Title: Advisory Committee on Reactor Safeguards
Thermal Hydraulic Phenomena Subcommittee

Date: Wednesday, August 22, 2001

THERMAL-HYDRAULIC PHENOMENA SUBCOMMITTEE

Steady State In-Channel Axial Void Fraction

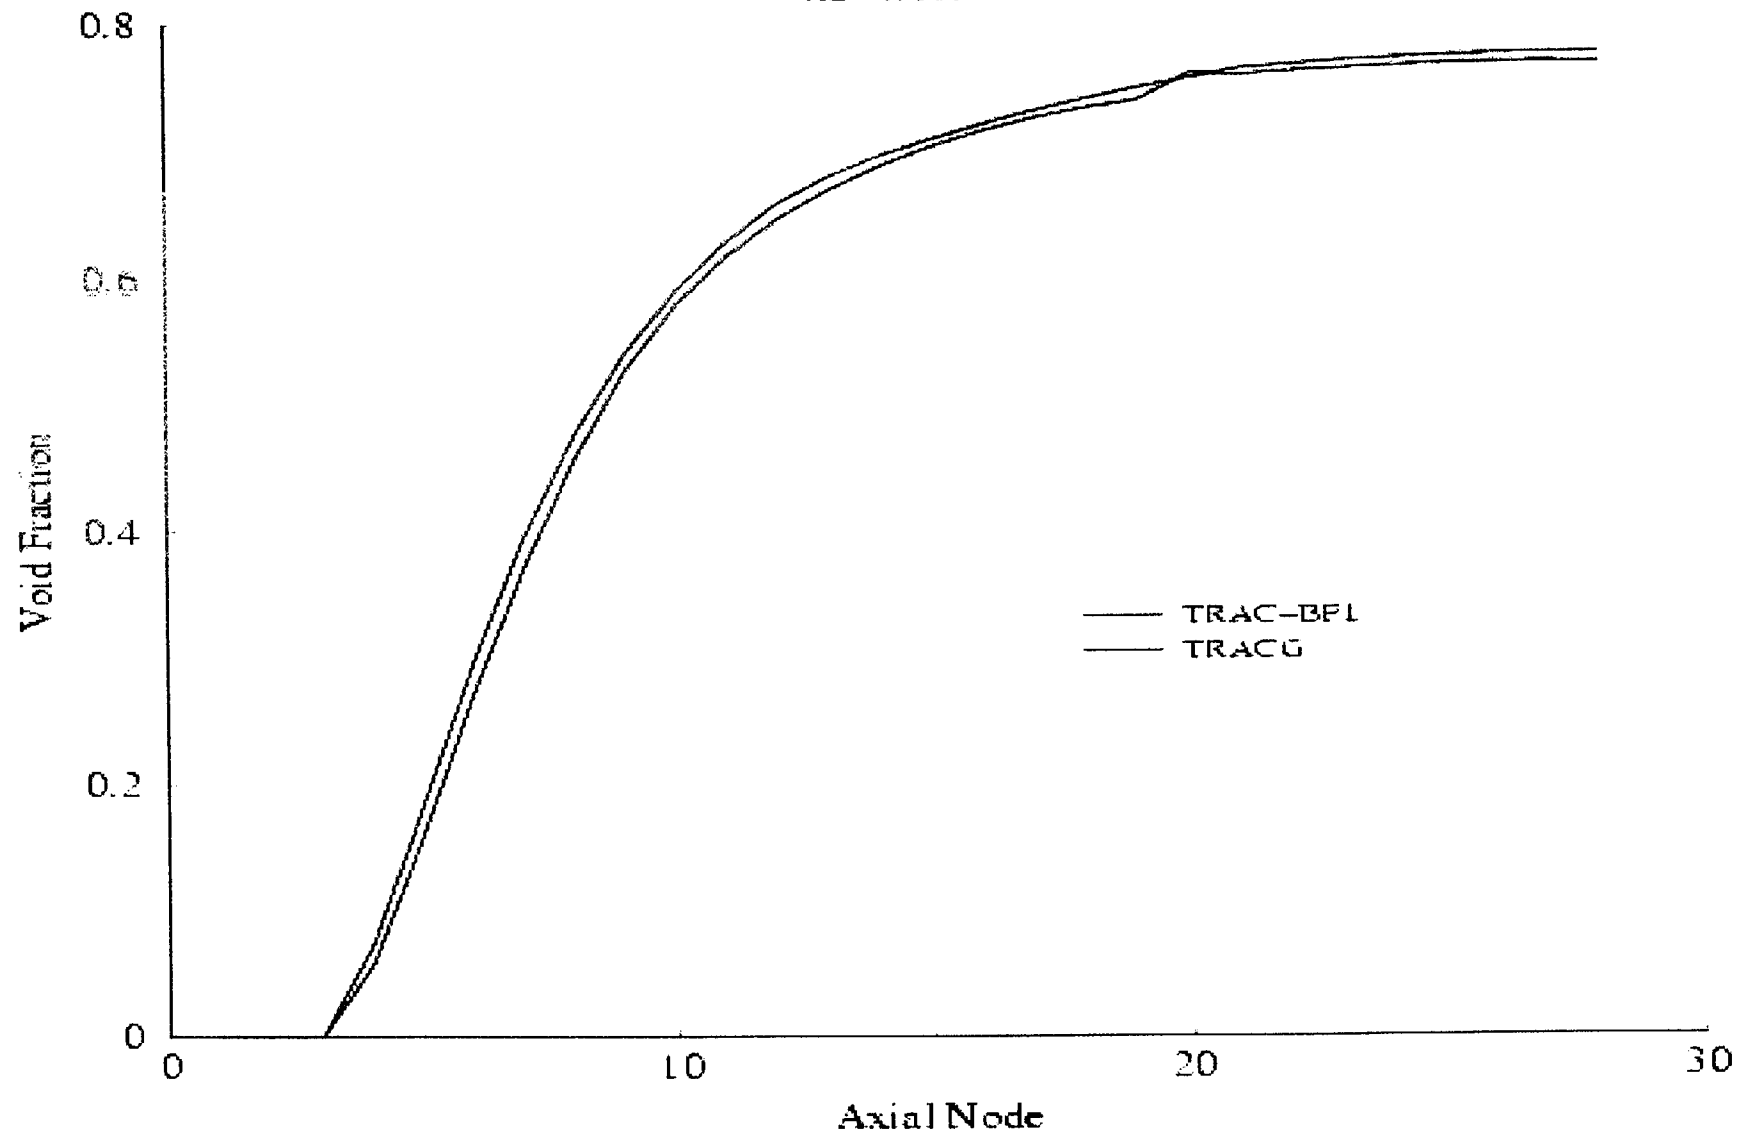
1 I just wanted to put up again the axial
2 void fraction profile radially collapsed, one-
3 dimensional. The only difference is this little
4 change here and that comes in because of the existence
5 of the part length rods and that's the TRACB modeling.
6 There's a difference. You could go into the part
7 length rod and region. But again, as you'll see, it
8 does not have an effect on the overall bottom line
9 answer.

Figure 5 Total Reactor Power for Simulated Pressurization Transient

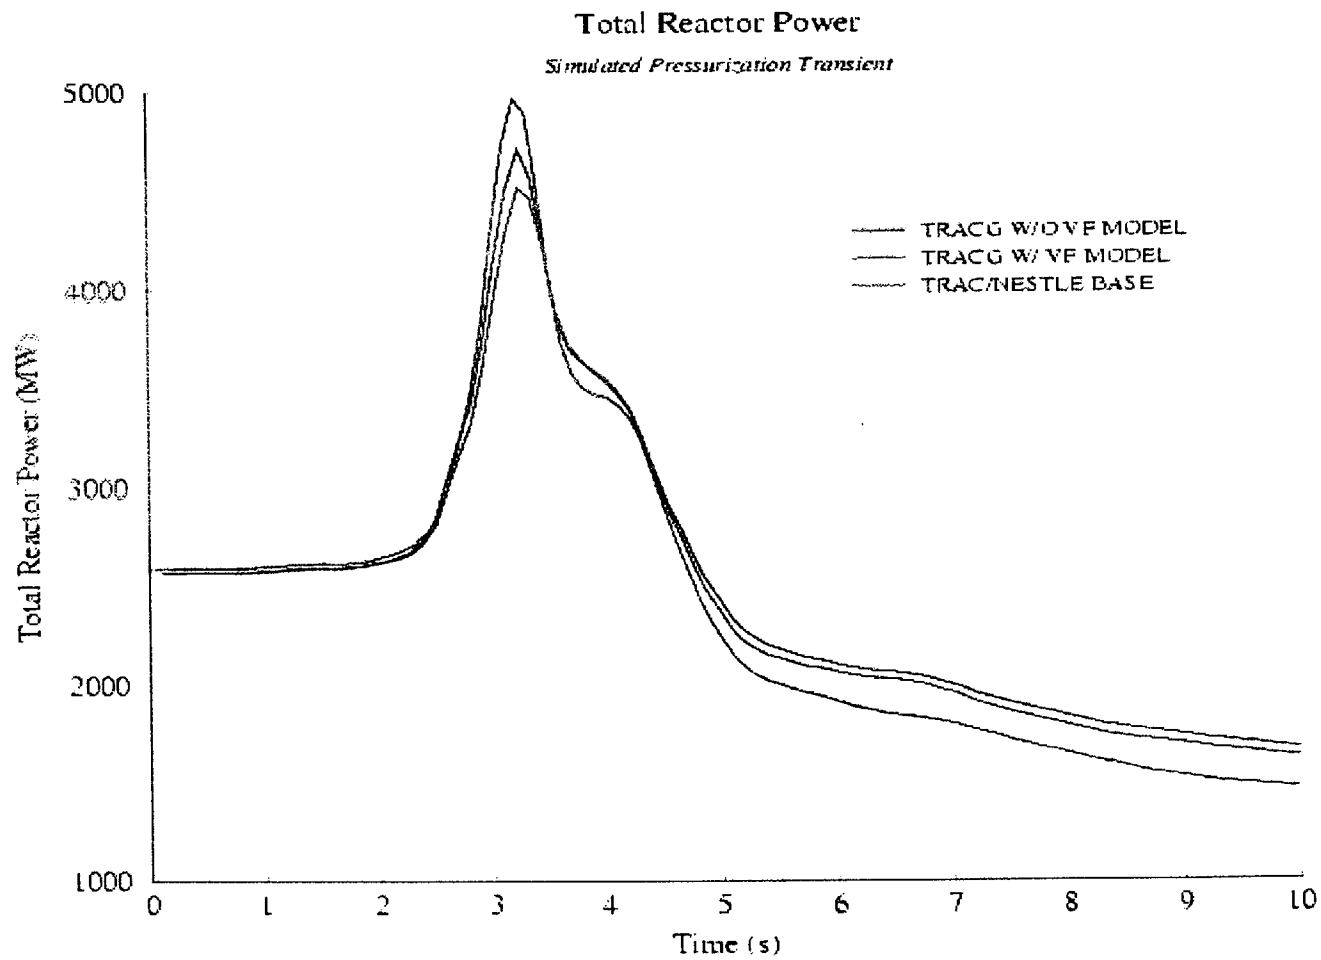
19 MR. ULSES: Which will also significantly
20 drop the power. That's what's going to happen. But
21 if you look at the bottom curve, which is just simply
22 the interval of the top of the curve, what you're
23 going to see is that the effect on the energy, which
24 is really the figure of merit for an AOO transient, is
25 effectively -- well, it's not nil. It's obviously

1 very difficult to see on this scale. But it's very
2 small which would mean that the actual calculated
3 change in the critical power ratio from these multiple
4 simulations would be very small which tells us that
5 these two codes obviously are able to predict that
6 this model is the same, if you will, in effect.
7 Obviously, there are some differences.

Figure 6 Comparison of Different Monte Carlo Evaluations of the Same GNF Lattice

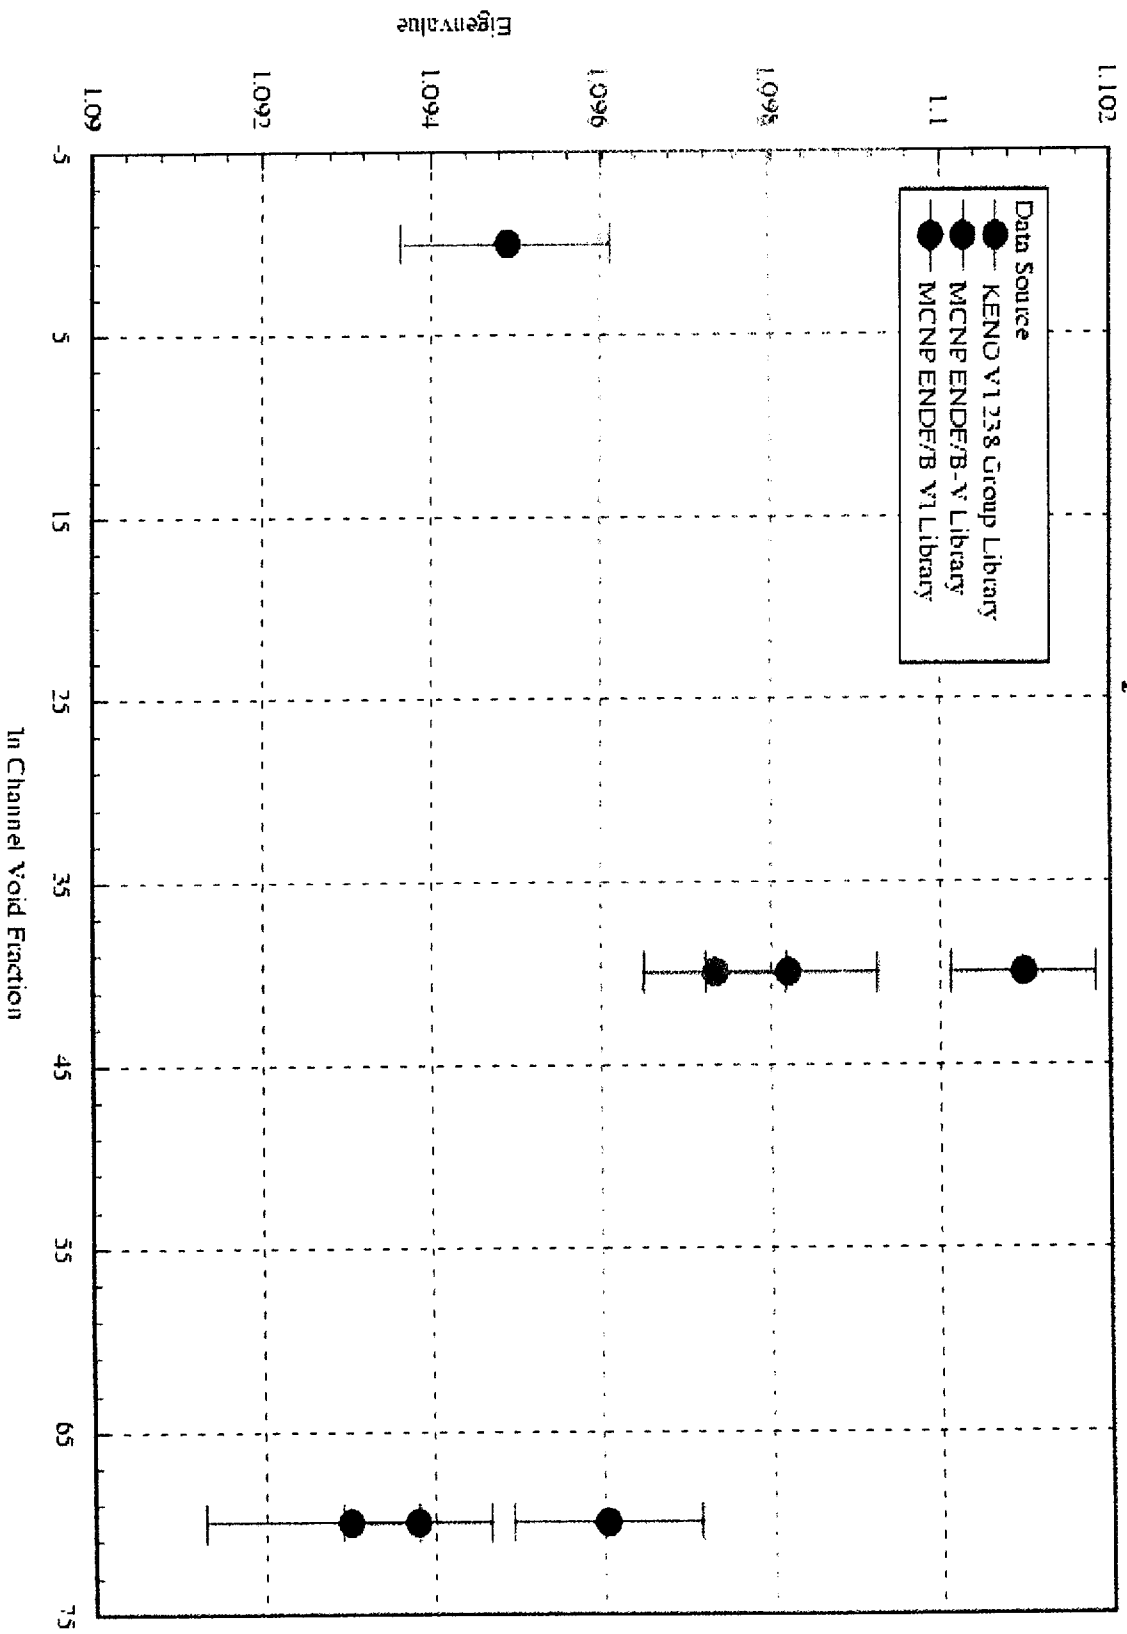
7 But if you look at this plot, it would be
8 equally valid to take the prediction down here versus
9 the prediction up here because again, this is a value
10 which is not a point value. All these values here
11 have been deemed to be effectively the same number
12 within the way that MCMP is usually applied. And if
13 you take this difference and you span this across this
14 curve, it will have an effect on the predicted power
15 response.

16 It's not going to be significant, but
17 there'll be an effect, and that's not accounted for in
18 this model and that's basically the problem that I had
19 with it, and that's why the SER is written as it is on
20 this particular model. It doesn't have a significant
21 effect on the bottom line answer, which is energy
22 deposition, but I don't believe that it's well enough
23 quantified in this context simply because of the lack
24 of the consideration of this uncertainty band.

1 lattice code and I wanted to compare it to MCMP, then
2 I would say if I had an answer which landed anywhere
3 within this error bound, I'd say I'm happy with that.
4 But I wouldn't go in and modify the results of my
5 lattice code based on that comparison. That's the
6 area where the staff is a little uncomfortable here.
7 Everybody goes out and they modify and they actually
8 validate their code against this number with the error
9 bars on it and if they say that the answer landed in
10 the error bars, I'm satisfied with that. But this is
11 the first application that the staff has come across
12 where they actually use this result to go in and
13 modify the results of the licensing tool within the
14 framework of a code application. And that's the area
15 where we had some questions. And this was the first
16 what I would call challenge of this review.
